On Comment #445

P802.3bq Rx CMNR ad hoc chair

Comment #445

<i>Cl</i> 113	<i>SC</i> 113.5.4.3	<i>P</i> 161	<i>L</i> 32	# 445
Frazier, Howard		Broadcom Corporation		
<i>Comment Type</i>	TR	<i>Comment Status</i>	D	<i>PMA</i>
If the editor's note is correct, then this draft was not ready for WG ballot.				
<i>Suggested Remedy</i>				
If the editor's note is incorrect, then remove it. If the editor's note is correct, then "confirm the source-adjustment criteria, measurement points, and levels used with the clamp methodology in this subclause" and restart the WG ballot.				
<i>Proposed Response</i>		<i>Response Status</i>	W	
PROPOSED ACCEPT IN PRINCIPLE. Remove editor's note.

Changes to 113.5.4.3

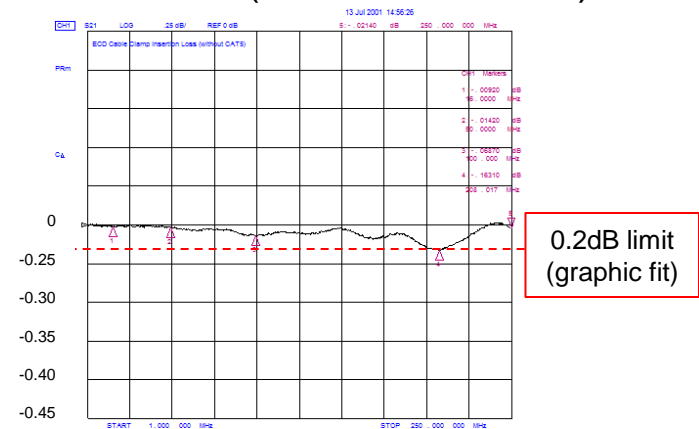
Editor's note (to be removed prior to publication): Commenters are encouraged to confirm the source-adjustment criteria, measurement points, and levels used with the clamp methodology in this subclause.

An 80 MHz to 2000 MHz test can be made based on the cable clamp test **described in Annex 113A** ~~defined in 40.6.1.3.3~~, a 30 meter plug-terminated ~~Category 8~~ channel that meets the requirements of 113.7, and suitable broadband ferrites. All components in the test remain over the ground reference plane. A sine wave with the amplitude held constant over the whole frequency range from 80MHz to 2000MHz, with the amplitude calibrated so that the signal power measured at the output of the clamp does not exceed 6dBm, is used to generate the external electromagnetic field and corresponding shield current.

~~Editor's note (to be removed prior to publication): Commenters are encouraged to confirm the source-adjustment criteria, measurement points, and levels used with the clamp methodology in this subclause.~~
